AGENDA

President and Board of Trustees
Village of Arlington Heights
Board Room

February 20, 2017

C2.1

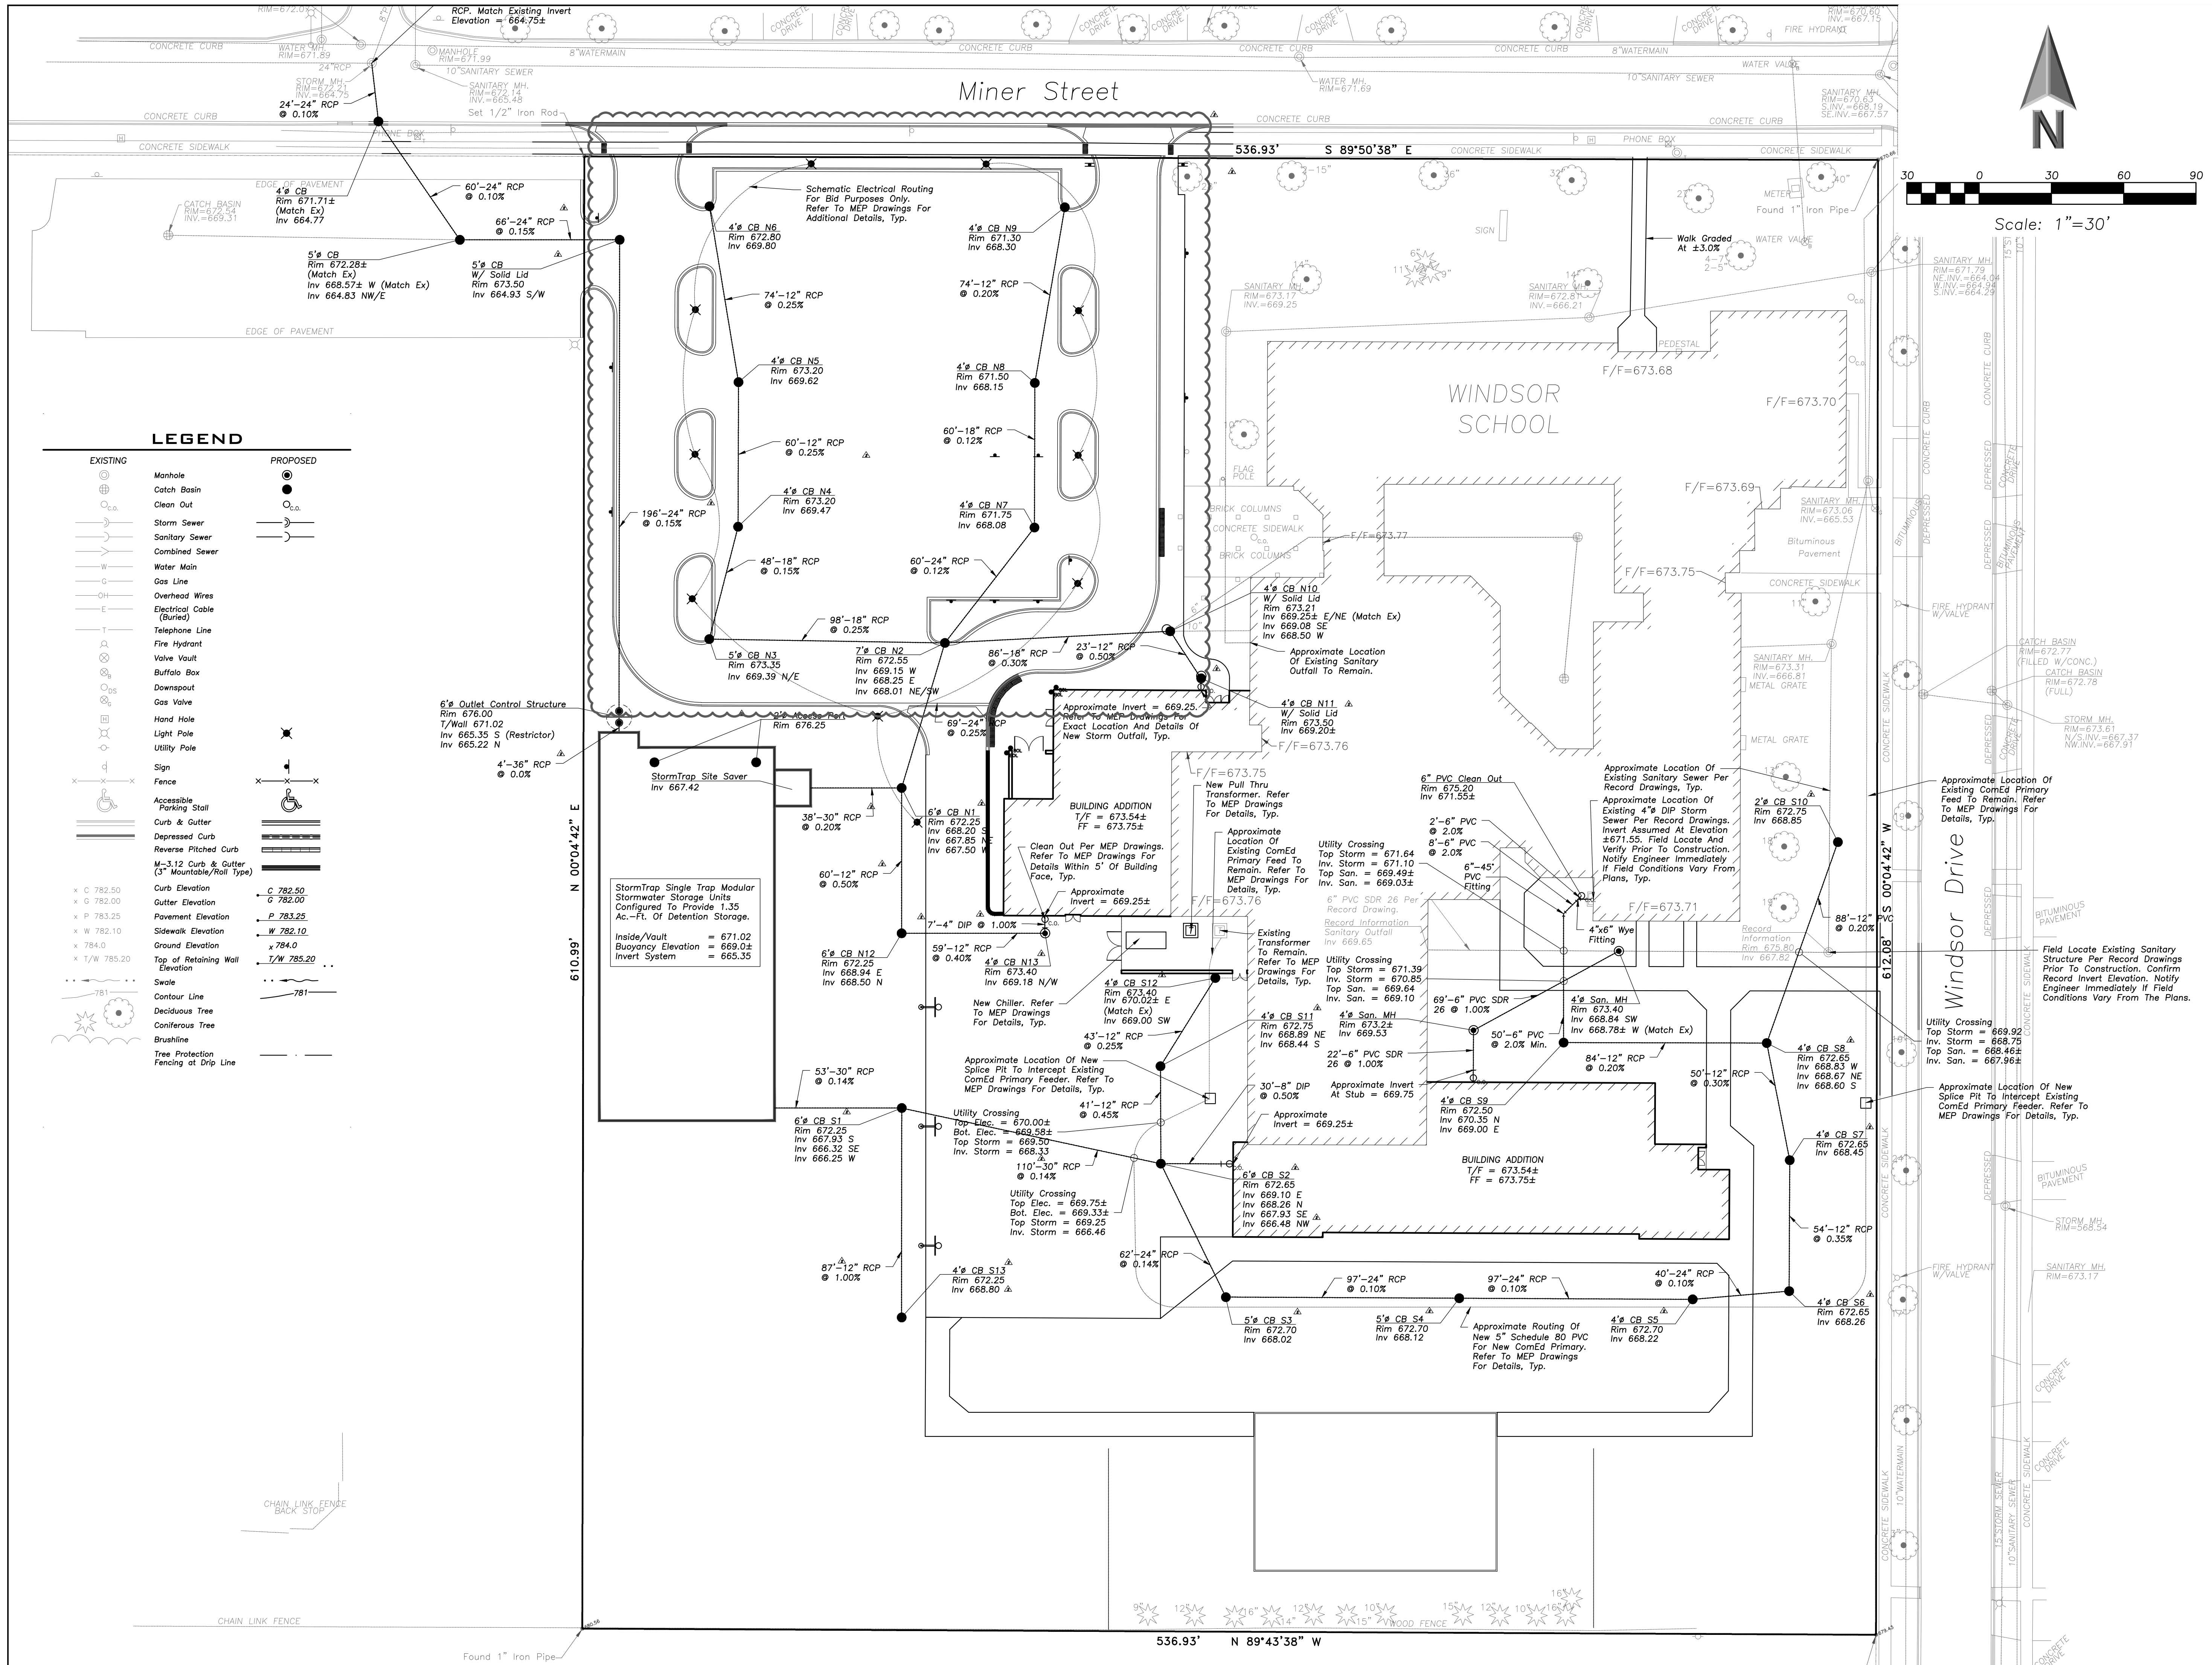
14. Please revise sheet C2.1 of the engineering plans to show the proposed setbacks of the building addition to the property lines.

24. In counting the total number of parking spaces as shown on sheet C2.1 of the engineering plans, it appears that only 90 parking spaces have been proposed, however, all documents submitted indicated that 92 parking spaces are proposed. Please clarify the total number of parking spaces proposed. One of the labels which total the number of parking spaces in a parking row indicates 12 parking spaces and 1 handicap will be provided, however, the row actually contains 10 parking spaces and 2 handicap spaces. Please revise this sheet to reflect the correct number of parking spaces. Additionally, the Traffic and Parking Study states that 92 spaces will be provided on the site; please revise this study to reflect that only 90 spaces will be added. Finally, please revise the Written Justification for Variation approval to reflect the correct number of parking spaces that will be included on the site.

25. Please revise sheet C2.1 to include "Do Not Enter" signage facing Miner Street at the "exit only" drive aisle where the drive aisle connects to Miner Street.

31. The response to comment #14 is noted but does not address the comment. To reiterate, the comment asked to show on sheet C2.1, the proposed setback of the building addition to the property lines. The revision to the plans only showed the required building setbacks. In other words, please indicate how far the gym addition will be located from the north and west property lines.

The proposed building setbacks have been added to Sheet C2.1.

Parking has been reconfigured from angled parking to 90 degree parking. See Sheet C2.1, Site Geometry Plan.

Distances from the addition to the property line are added to sheet C2.1

The parking stalls have been revised to 90 degree parking and designed in compliance with overhang requirements. See Sheet C2.1, Site Geometry Plan.
